## Memorandum

**Re:** Organoclay Geotextile Installation - Tar Body Removal Action  
NW Natural Gasco Site, Portland, Oregon

**Figure 1**  
NW Natural Gasco Site  
Reactive Geotextile Installation

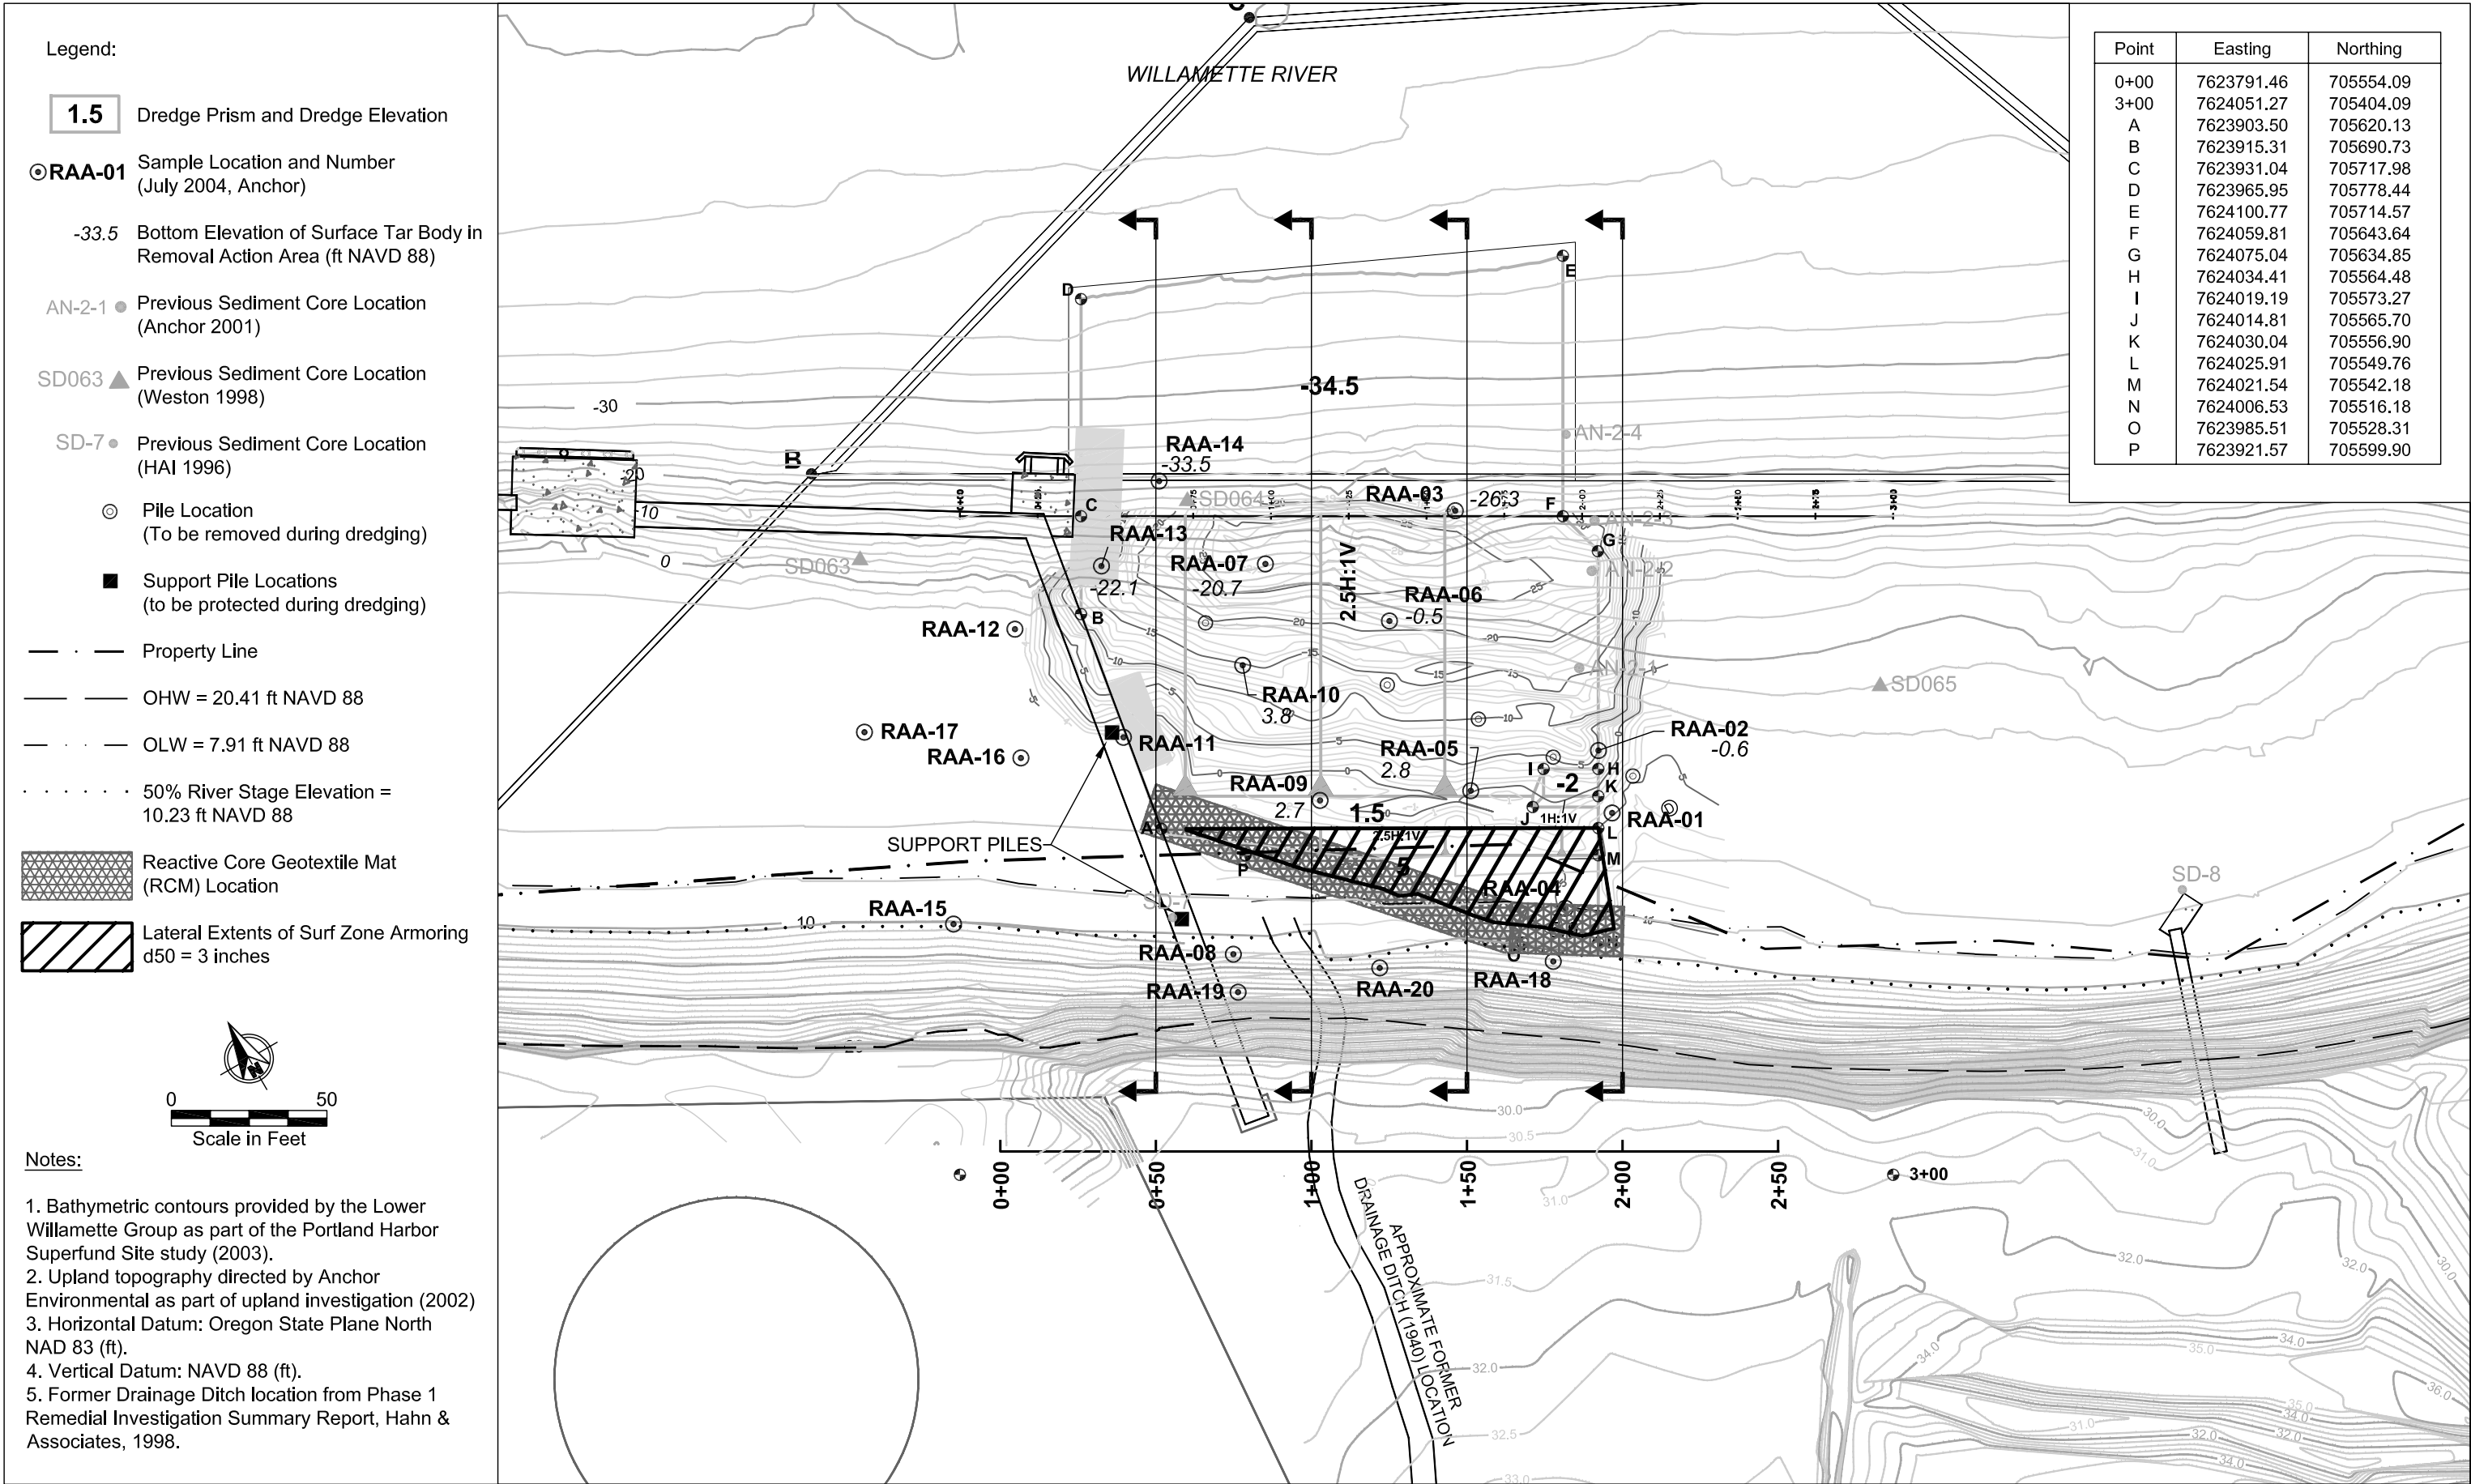
3. Place the an additional 6 inches of the Pilot Cap or Fringe Cover sand on top of the RCM to protect the RCM from the armor layer.
4. Place the 6-inch-thick armor layer on top of the sand on the flat bench. This armor layer is intended to provide protection for the Pilot Cap and RCM in the surf zone, and should consist of 6-inch minus rock with a  $d_{50}$  of 3 inches. The lateral extents of this armor layer are presented in Figure 1, and extend across the bench at elevation +5, and terminate at elevation 0.

**Figure 2**  
NW Natural Gasco Site  
Reactive Geotextile Section

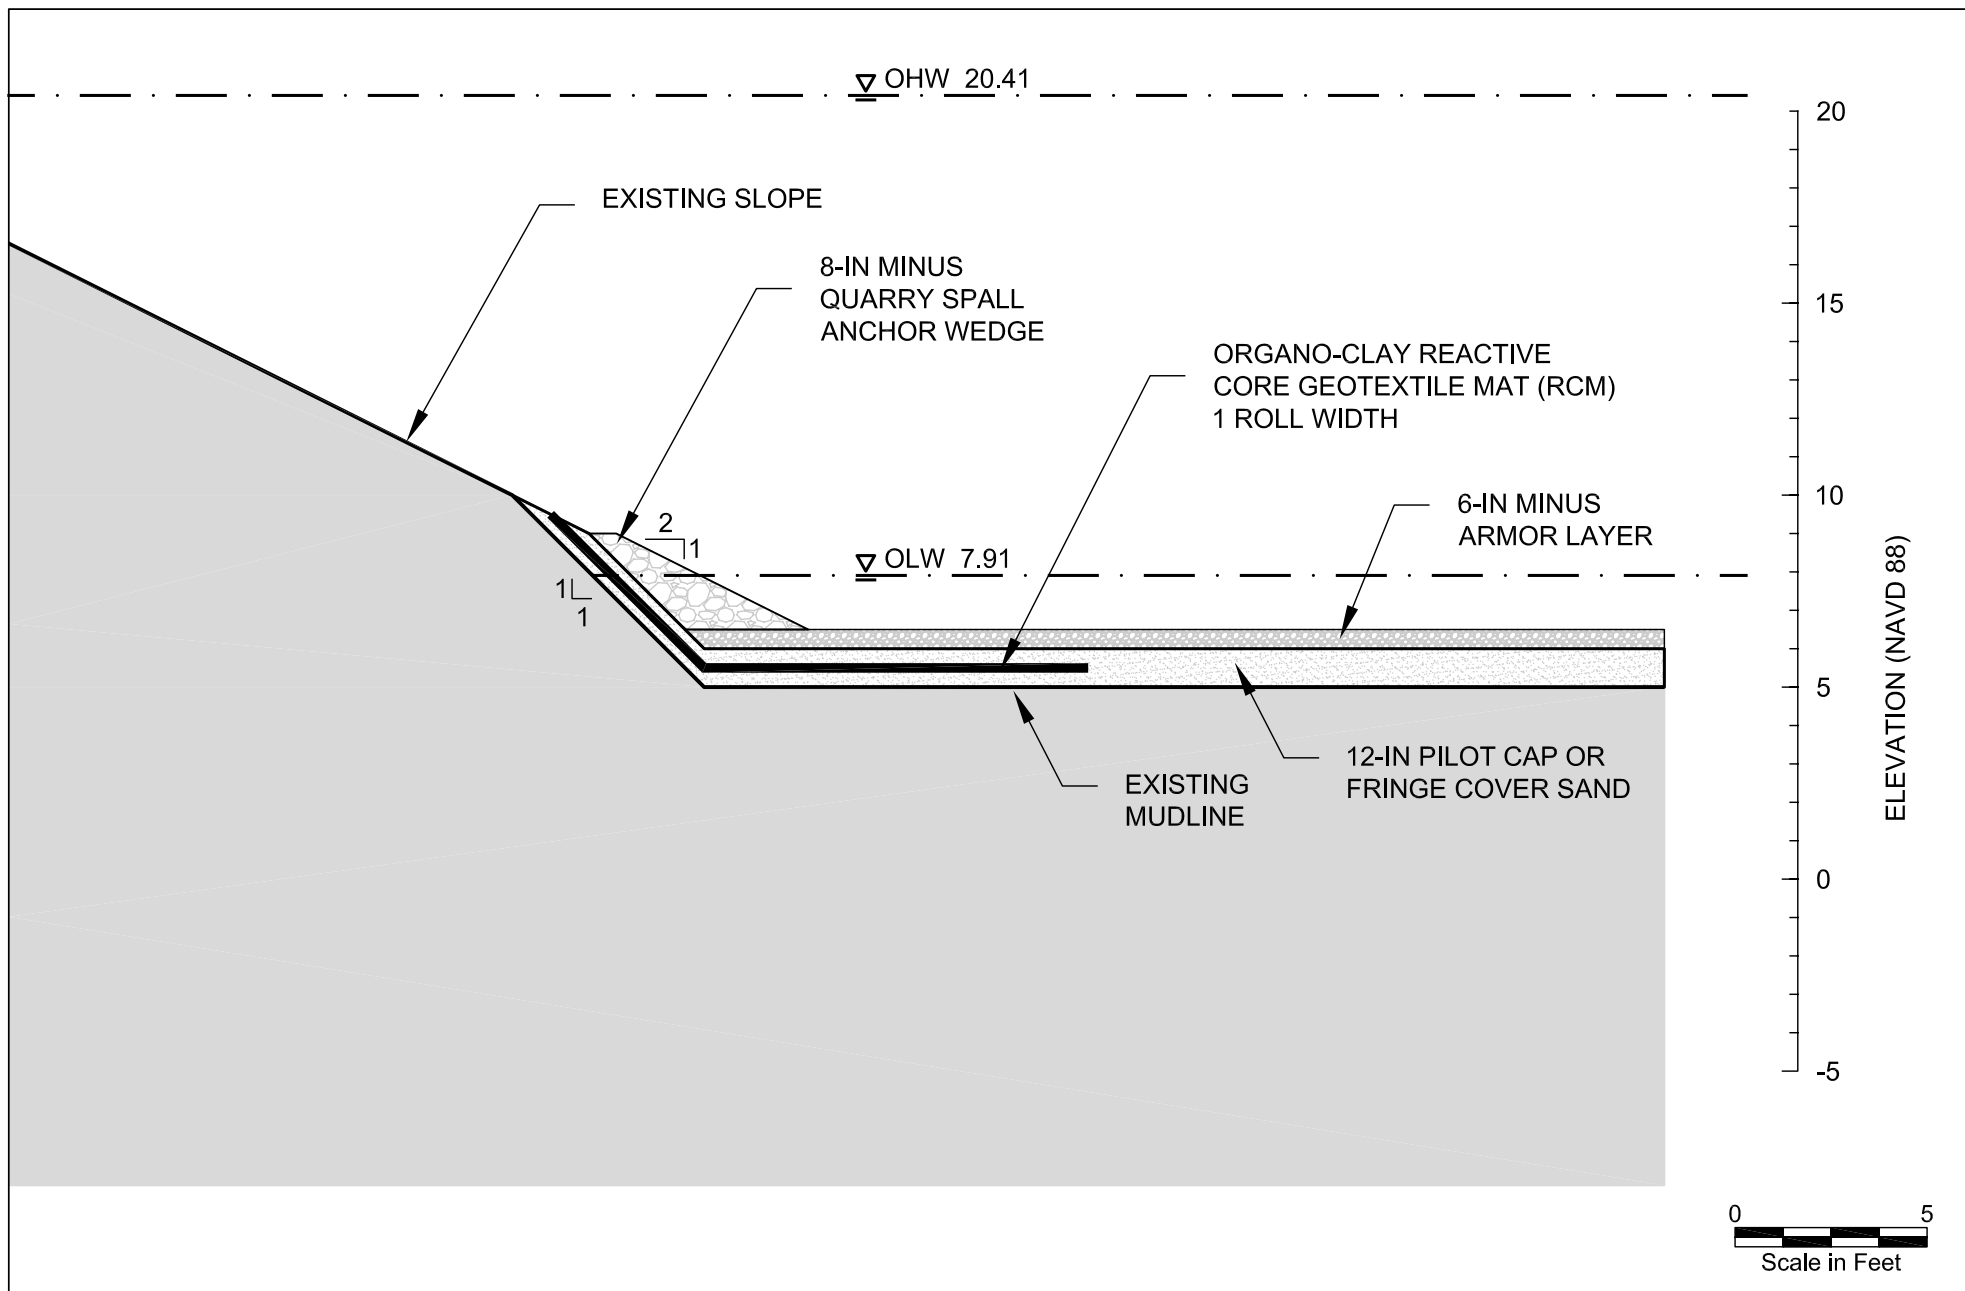
5. Place a wedge of 8-inch minus quarry spalls into the “notch” at the base of the cut face, as shown in Figure 2. This wedge is intended to permanently anchor the RCM in place.
